ITEM 4.1: Design Review Permit– 3200 Pleasant Grove Bl. – WRSP PCL W-16 – W-16 Multifamily Project – PL21-0373

REQUEST

The applicant requests a Design Review Permit for a 223-unit multifamily project on 12.16 acres in the West Roseville Specific Plan area. The development consists of 18 three-story, townhome-style buildings, including units with two-car garages, and one apartment/community clubhouse building. A total of 483 parking spaces, including 372 garage spaces, will be provided. Additional site amenities include an outdoor pool/spa area, and clubhouse building with lounge, fitness studio, offices, storage, and other facilities.

Figure 2 – Project Site Plan

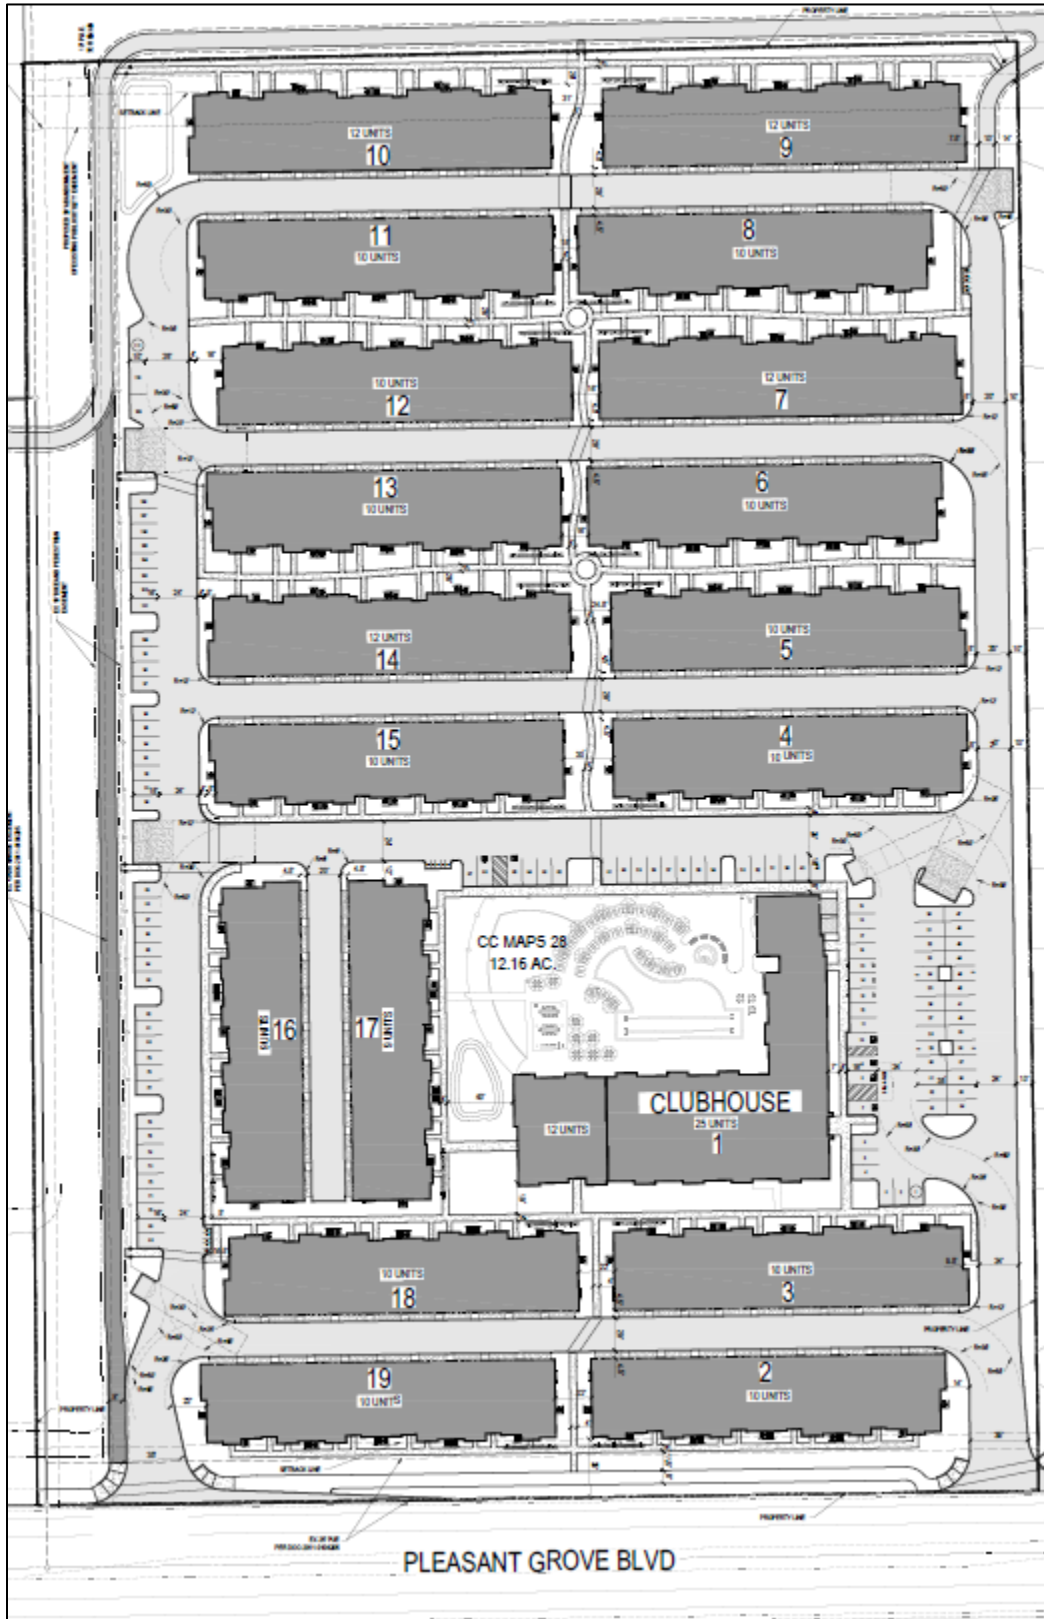
Open Space: The proposed project includes open space areas within the site plan, as well as a visual connection to the adjacent open space parcel. Within the project site, open space is provided in the outdoor lounge area around the clubhouse. In addition to the pool, the site plan shows a spa, grilling area, and outdoor seating and lounge areas.

WRSP Parcel W-81 is located to the north of the project site, and is designated as an open space preserve. All units along the northern boundary are oriented towards the open space, and a walkway will provide connection to the portion of the trail that will border the subject parcel to the north. The project includes a four-foot-tall tubular steel fence along the western and northern property boundaries, consistent with the fencing requirements for residential and open space interface in Section 12.2.6.3 of the WRSP. The interface with the open space preserve is consistent with the WRSP, and the provision of open spaces within the project is consistent with the CDG.
